# FORM-BASED ZONING REPORT

**▶ FILE #:** 4-A-26-OB **AGENDA ITEM #:** 12  
 POSTPONEMENT(S): 4/9/2026, 5/14/2026 **AGENDA DATE:** 6/11/2026  
**▶ APPLICANT:** RYAN ROBERTSON  
 OWNER(S): Doyle E Arp Kerbela Temple Holding Corp.

Purpose of Request: Level III Alternative Compliance Review in the SW-6 and SW-5 (South Waterfront) district for a proposed multi-family development

**Zoning Administrator Report for Level III: Alternative Compliance Review**

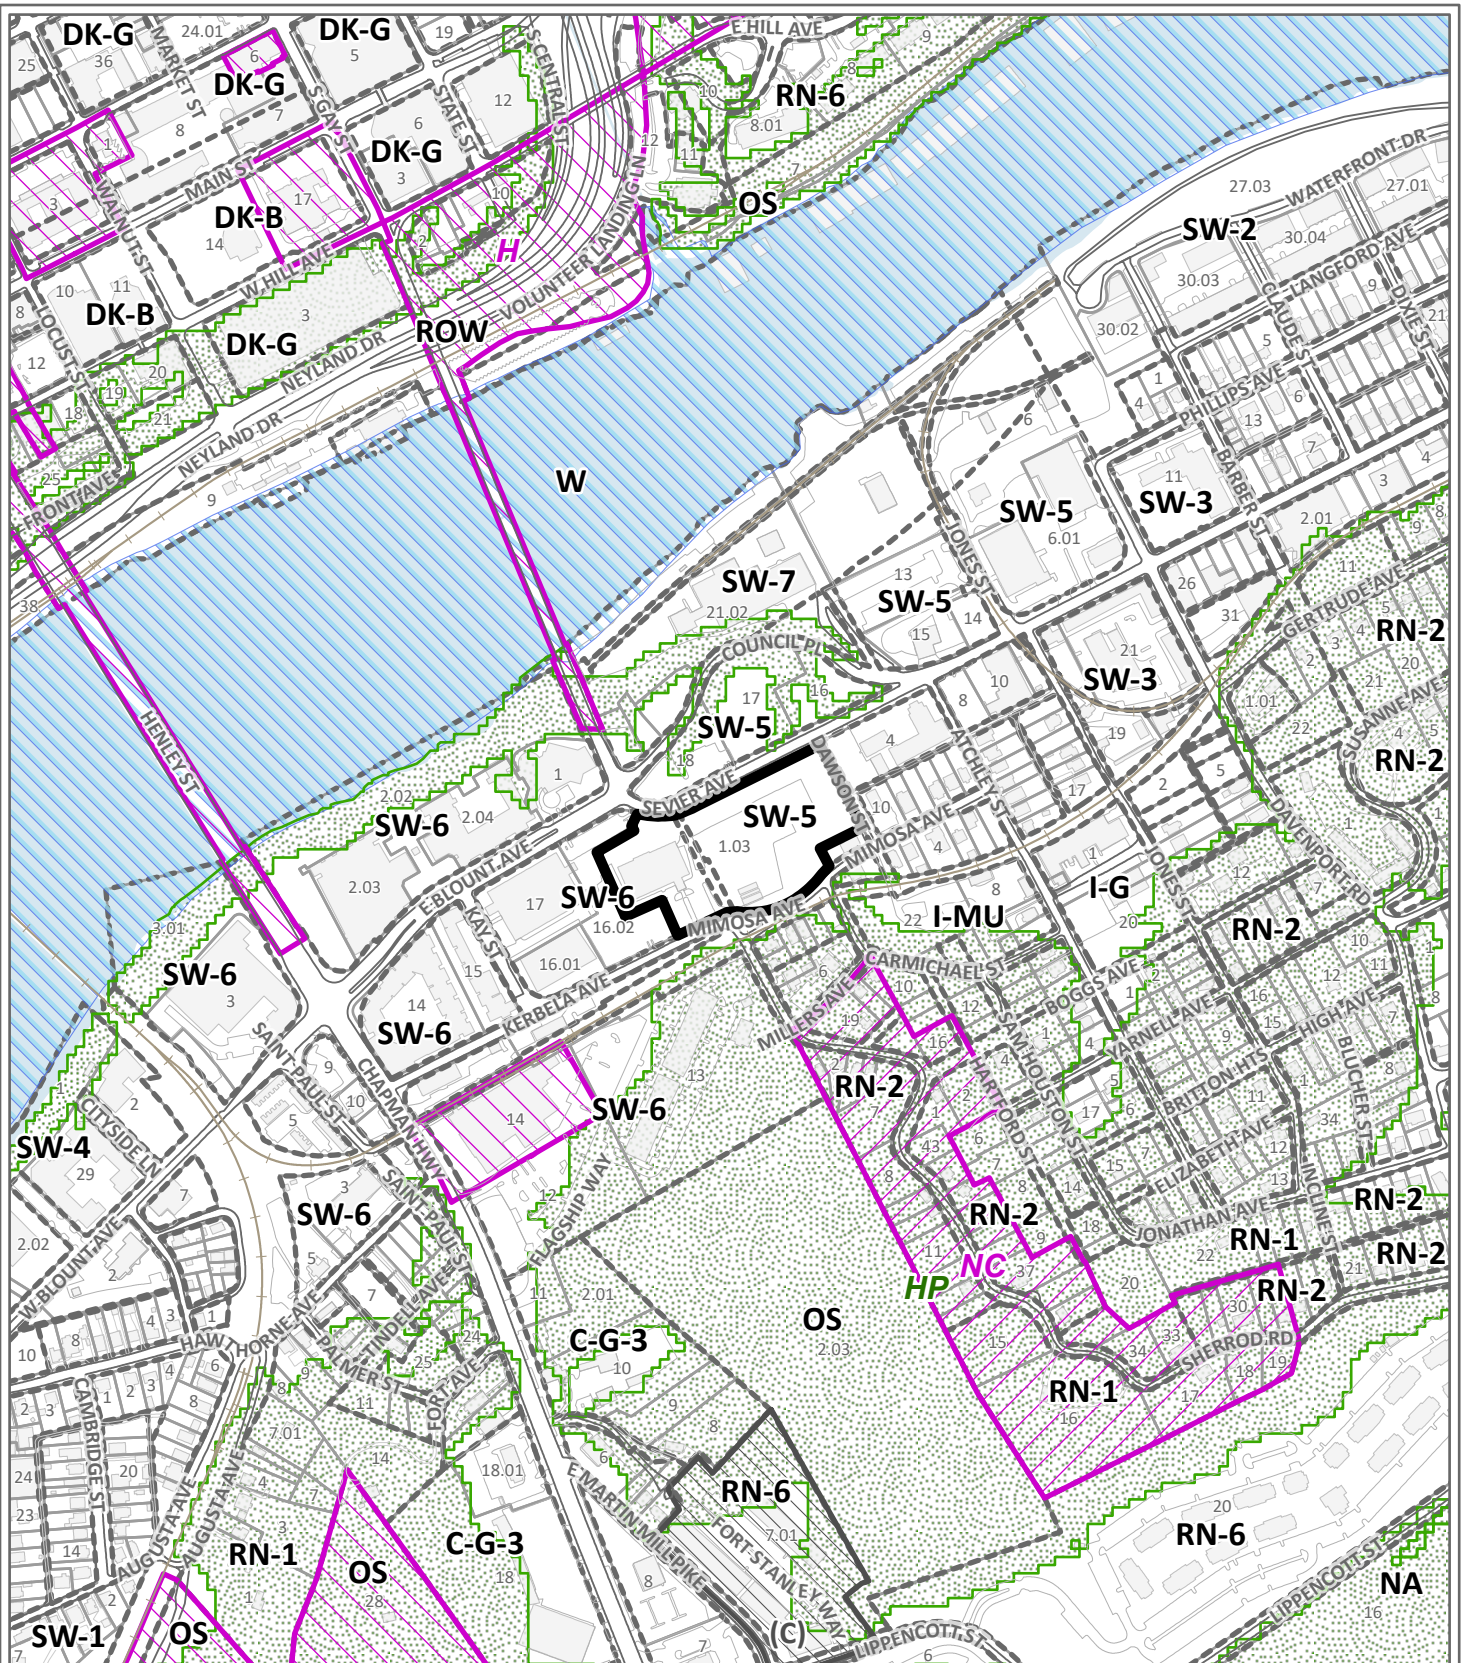
3. Lighting the existing rock pile and providing an art installation to activate the Sevier Avenue and Dawson Street corner of the property. [Rendered Site Plan (New Design), page 34 of the plan set (revised 5/27/2026), and the corner activation narrative in Exhibit D, applicant's response document]

# SITE GRADING DIAGRAM

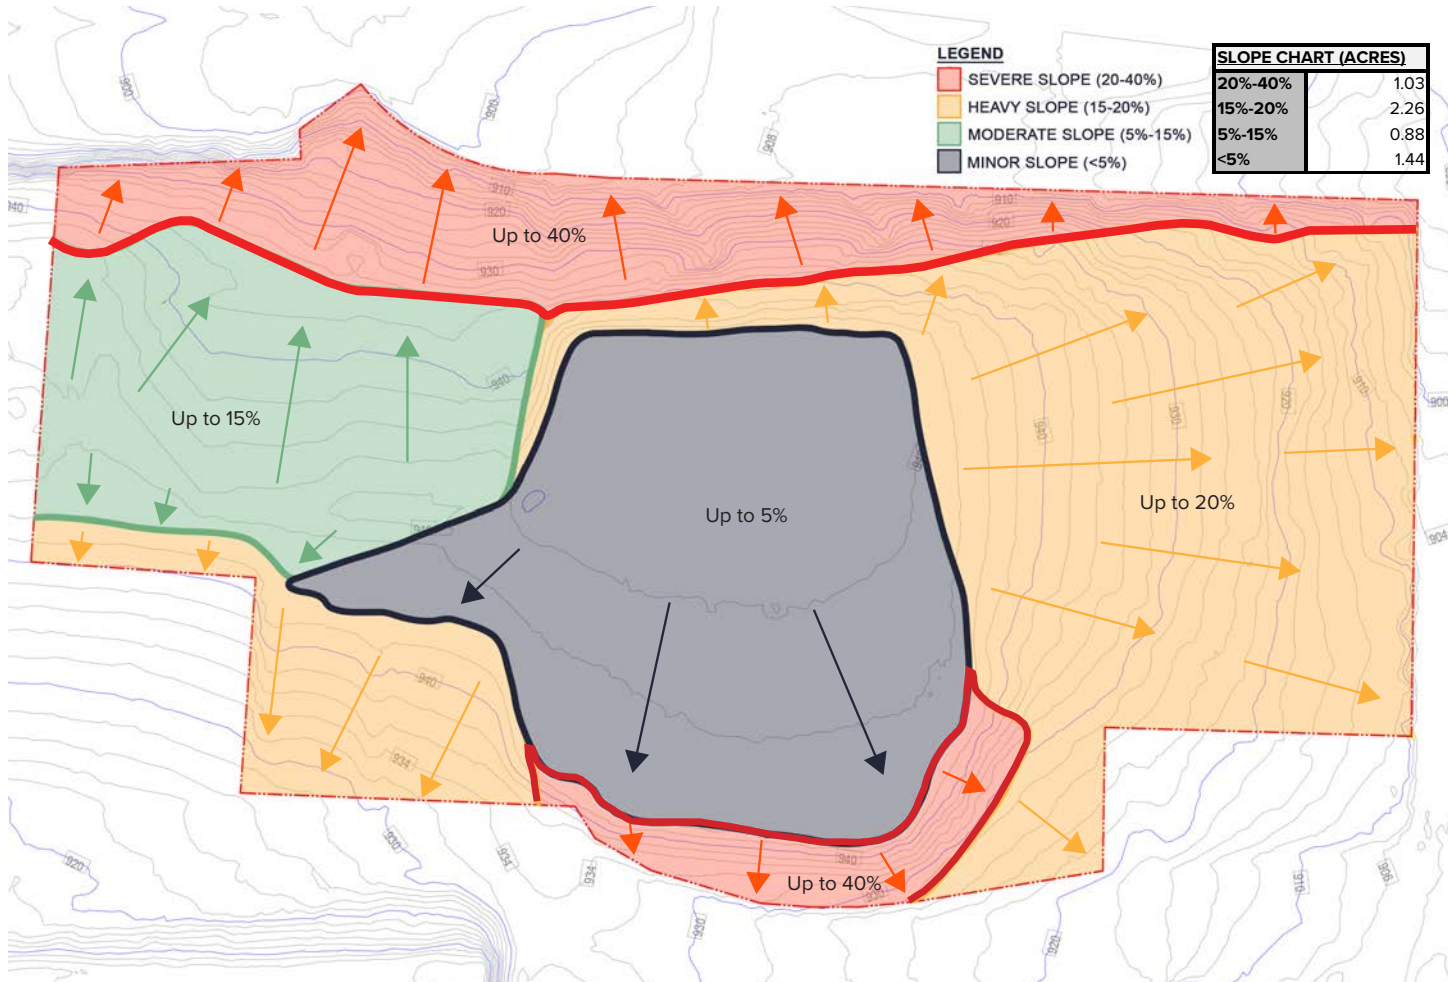
- When scaled, at least two locations still appear to exceed 2H:1V slopes. Detailed design review may require additional retaining walls so as not to impact the site layout.

# North Elevation

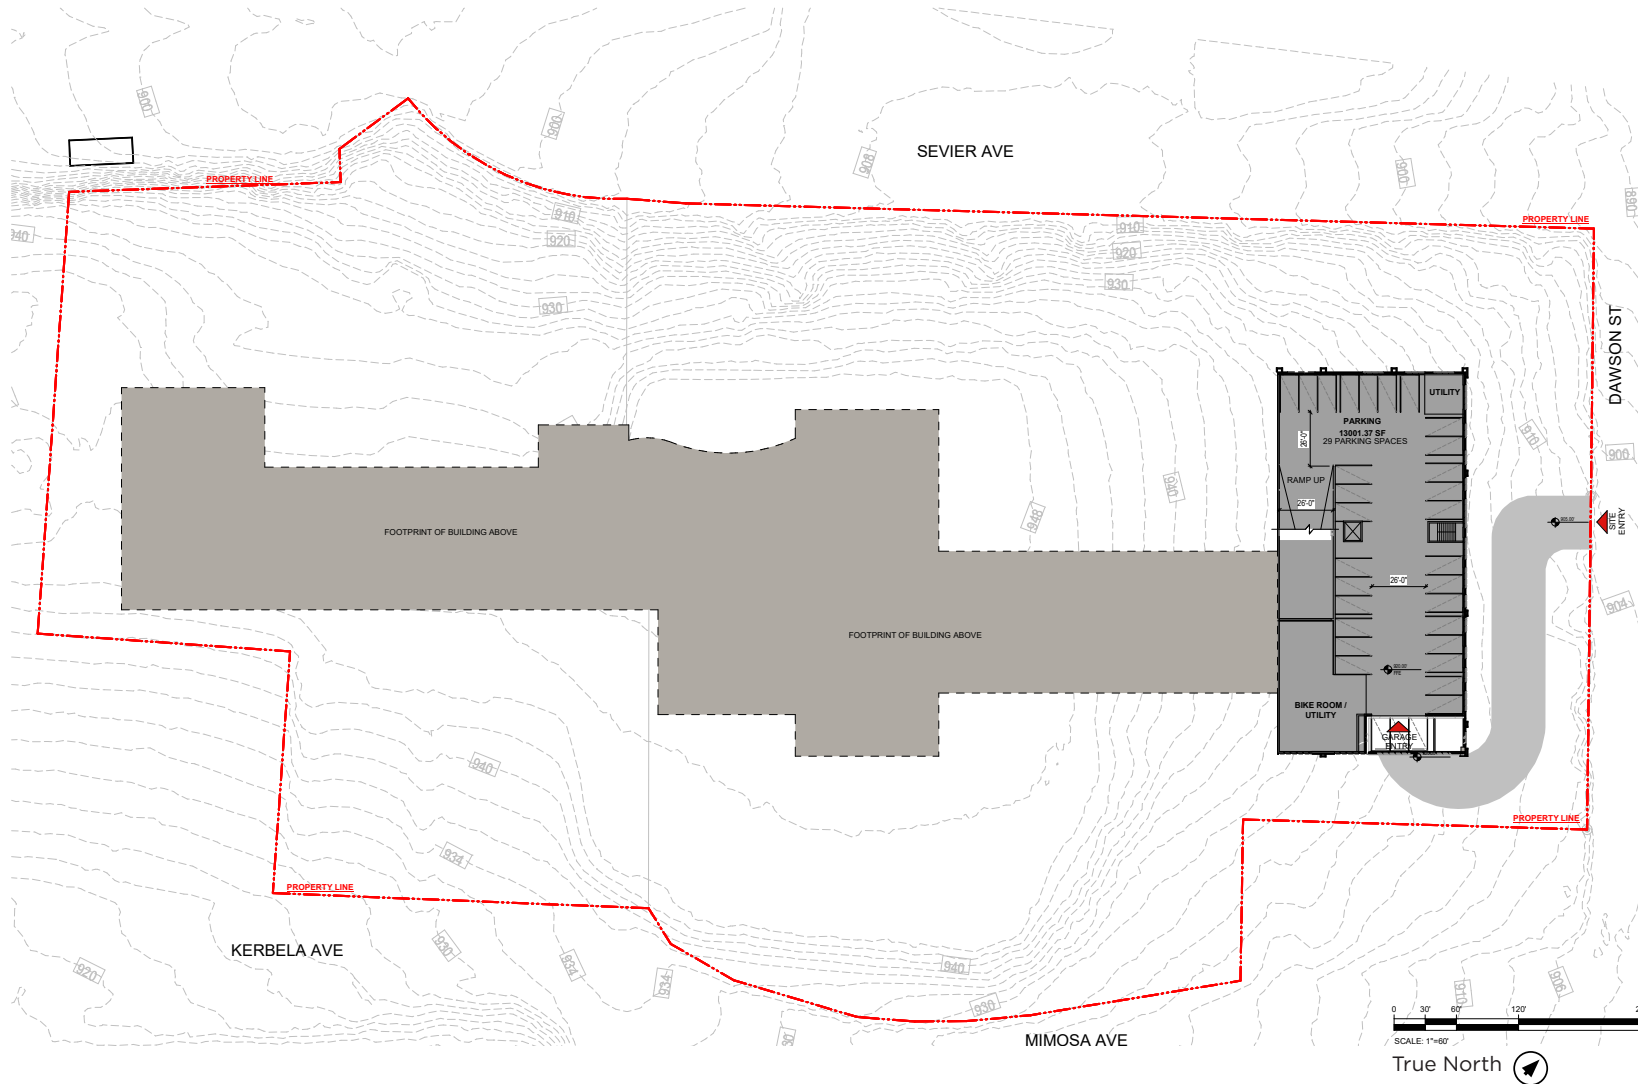
The provided elevations show a ground floor glazing calculation of 71%; however, there is a note that suggests that the ground floor area of the garage was excluded from the calculations. The ground floor area of the garage shall be included in the calculations, and the complete ground floor transparency calculation is unable to be determined on your elevation plan. Our updated ground floor glazing elevation reaches 63% due to the slope perpendicular to Dawson Street exceeding 22%.

Ground Floor Glazing Calculation:  
 Wall Area: 5,714 SF\*  
 Glazing Area: 4100 SF\*  
 Percentage: 71.7%
